Our Ref: KC2225/MS

**Proposed Development of Curraghinalt Mine
Response to NIEA letter of 18th November 2021; Ref: TC80/20, AIL/2020/0105, AIL/2020/0106**

NIEA issued by letter of 18th November 2021 to DGL a Further Information Request under the Water (NI) Order 1999 and the Abstraction and Impoundment (Licensing) Regulations (NI) 2006 related to:

Figure 1: Stages of Water Balance Test

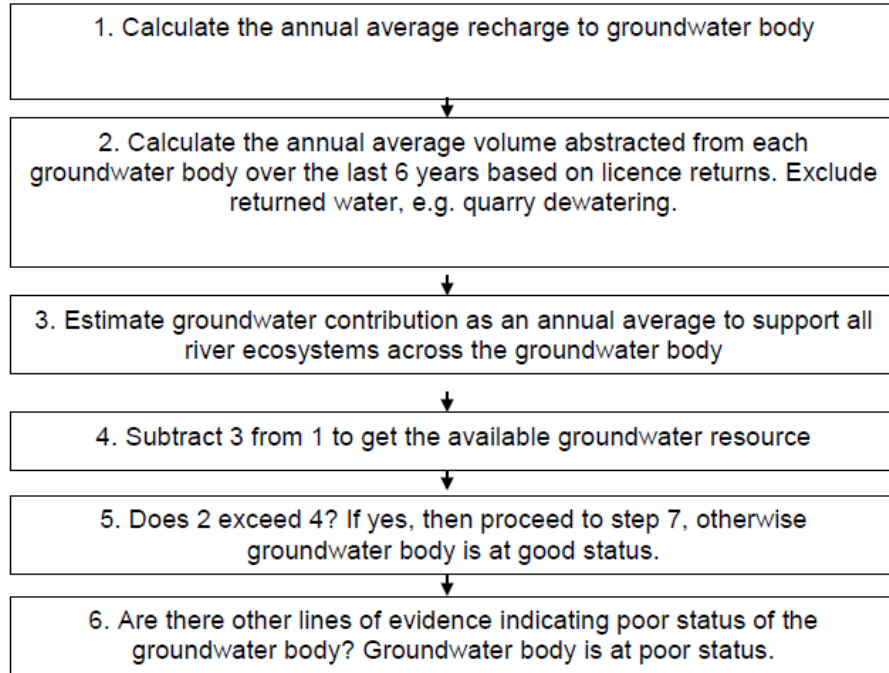
The NIEA letter specifically asks for '*supporting information to verify whether the proposed abstraction will impact the status of the groundwater body based on the water balance test*'.

The methodology for the Water Balance Test is outlined in '*River Basin Management Plans (2015 – 2021): Groundwater Classification Methodology Water Balance, December 2015*' published by the Northern Ireland Environment Agency (the 2015 NIEA Methodology). Figure 1 below describes the stages identified in the 2015 NIEA Methodology.

UKTAG guidance (para 4.4) states that *'Abstracted groundwater that has been locally returned to the aquifer or to a river should be discounted (for example, this may occur at a quarry/mine dewatering operation'*. The specific reference to mine dewatering is noted. This guidance is reinforced in the 2015 NIEA Methodology and Figure 1, where abstracted water that is returned (e.g., quarry dewatering) is excluded from the calculation.

Therefore, following UKTAG and NIEA guidance the proposed abstractions are excluded from the Water Balance Test. As a result, given that the abstracted volume from the Gortin groundwater body would not be increased within the Water Balance Test calculation (Step 2 in Figure 1), there will be no impact on the status of the Gortin groundwater body as a result of the Water Balance Test.
